February 17, 2009
NND-09-0025

Subject: Virgil C. Summer Nuclear Station (VCSNS) Units 2 and 3 Combined License Application (COLA) - Docket Numbers 52-027 and 52-028 Response to NRC Request for Additional Information (RAI) Letter No. 014

Reference: Letter from Tanya Simms (NRC) to Alfred M. Paglia (SCE&G), Request for Additional Information Letter No. 014 Related to SRP Section 8.2 for the Virgil C. Summer Nuclear Station Units 2 and 3 Combined License Application, dated January 21, 2009.

SRP Section: 8.2 Offsite Power System

Updated VCSNS Units 2 and 3 Switchyard Single Line

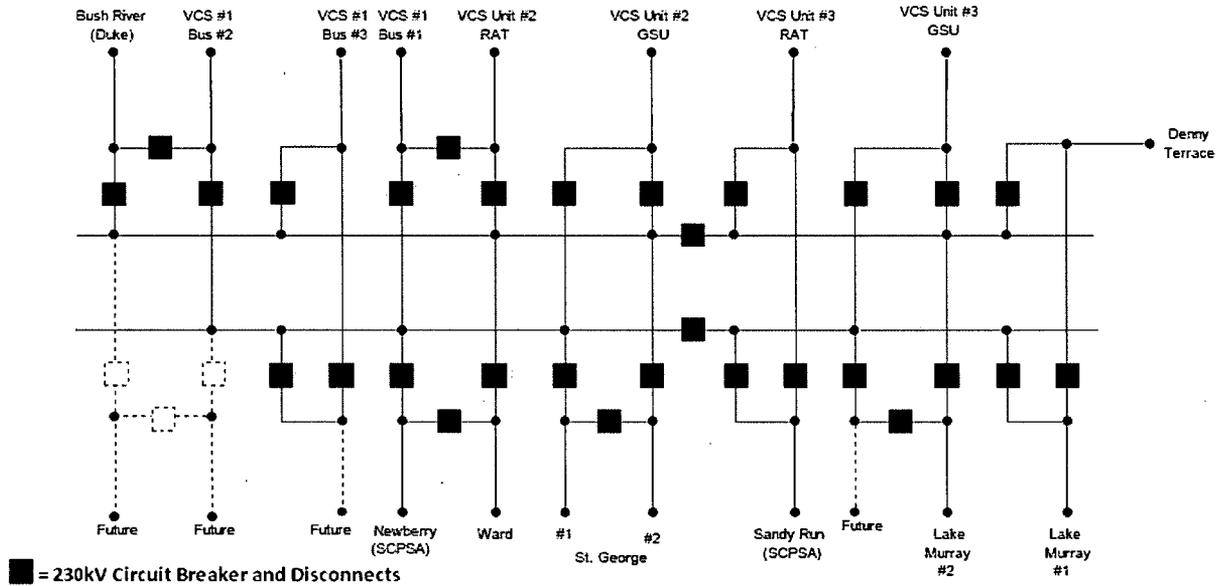
RG 1.206, Part I, Position C.I.8.2.1 states that a COL applicant for passive design should provide a discussion in the FSAR of how the single designated offsite power circuit from the transmission network conforms with the requirements of GDCs 5, 17 and 18 (also see guidance in Standard Review Plan Section 8.2.II). Discuss how the FSAR addresses this consideration or justifies an alternative, as well as how South Carolina Electric & Gas intends to meet the requirements of 10 CFR 50.65 with respect to maintenance of onsite and offsite power system components.

capability to supply the switchyard all electric power generated from their respective AP1000 unit. The line for Unit 2 does not share a common structure with the line for Unit 3. The lines connect to the new switchyard in a double bus/ double breaker configuration as shown in the Updated VCSNS Units 2 and 3 Switchyard Single Line (see diagram below), which will be updated in the next annual COLA revision to reflect the matured design.

Due to maturing design, the switchyard design has changed to place the generator step-up transformer (GSU) connections in their own bay in a double bus/ double breaker configuration. This design change isolates the GSU connections from faults occurring on transmission lines by eliminating a shared breaker in the breaker-and-a-half configuration. The reserve auxiliary transformer (RAT) and transmission line connections remain connected in a breaker-and-a-half configuration. The COLA will be revised in a future update to reflect these changes as described in this response. These changes are illustrated in the response to VCSNS RAI 08.02-3 figure, Updated VCSNS Units 2 and 3 Switchyard Single Line. This change does not alter the conclusions of FSAR Subsections 8.2.1.1 or 8.2.2.

COLA Part 2, Figure 8.2-202 will be revised in a future to reflect the changes as shown in the Updated VCSNS Units 2 and 3 Switchyard Single Line.

3. COLA Part 2, FSAR Figure 8.2-202 will be revised as indicated in the response to RAI 08.02-2.
